MEMORANDUM

Subject: Response to ACRS Question (April 2, 2009 Meeting)

Figure 1. Comparison of the coast-down curve used in the prior analysis to that determined from new measurements.

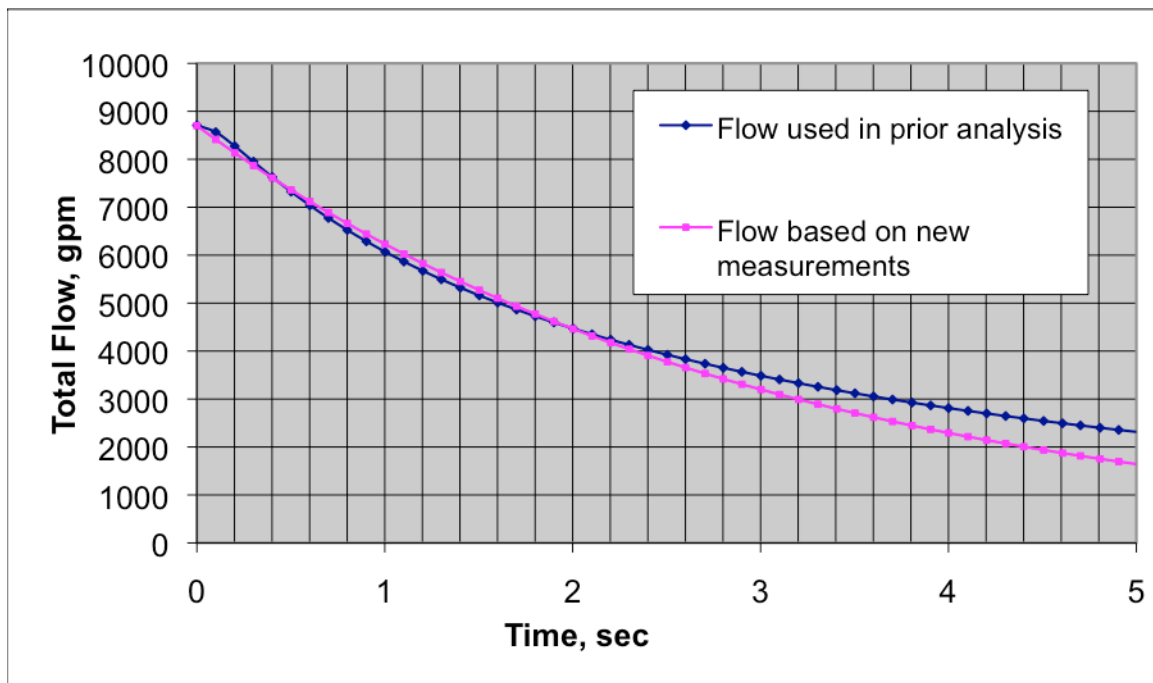
During our analysis of an accident postulated by the ACRS (accidental closing of the valve in the reactor outlet line, DWV-19), we became aware of a possible problem in our original analysis of the transient related to a loss of off-site power. In that analysis, a coast-down curve was derived within RELAP, based upon pump characteristics and the flow geometry. This curve was compared to a coast-down curve measured before initial reactor criticality, and shown to be conservative. However, the original curve was not measured under conditions appropriate to the accident being analyzed. In the figure below, the flow for the initial few seconds of the new curve is compared to that used in the prior analysis. It should be noted that the minimum Critical Heat Flux Ratio (CHFR) occurs during this time period. In order to address this issue, the primary coast-down curves were recently measured under various conditions, including the limiting case of no shut-down pump starting. The measured curve for the limiting case was ten used to derive a model as input to RELAP for complete re-analysis of the accident scenarios explored in the original analysis.

From the figure, it is clear that the two curves are almost identical for the first 3 seconds, and this fact is reflected in the analysis using RELAP. The minimum CHFR occurs in the outer plenum approximately 1.5 s after the primary pumps trip, and is 2.17 as compared to 2.19 previously. This result is a direct consequence of the comparison shown in Fig. 1, which is in turn a measure of the conservatism in the coast-down curve used in the prior analysis. It should be noted that the present curve is a *conservative* representation of the measured curve, and that there is substantial conservatism in the new result (arising from non-local deposition of fission power, neglect of clad and meat thermal conductivity, changes in the distribution of heat deposition for fission product decay, and other terms).

The result of the Loss of Offsite Power accident analysis (and by extension, the Loss of Both Shutdown Pumps) is nearly identical to the initial analysis. The reactor scram was initiated by low flow to the outer plenum 1.4 seconds after the loss of power. The maximum fuel centerline temperature is 410 K, which occurs at the hot spot at the top of the hottest element in the outer core at the time of the scram. Long term cooling in the case of failed shutdown pumps is bounded by the case of the closure of DWV-19, in which the flow drops to zero just 4 seconds after the scram.
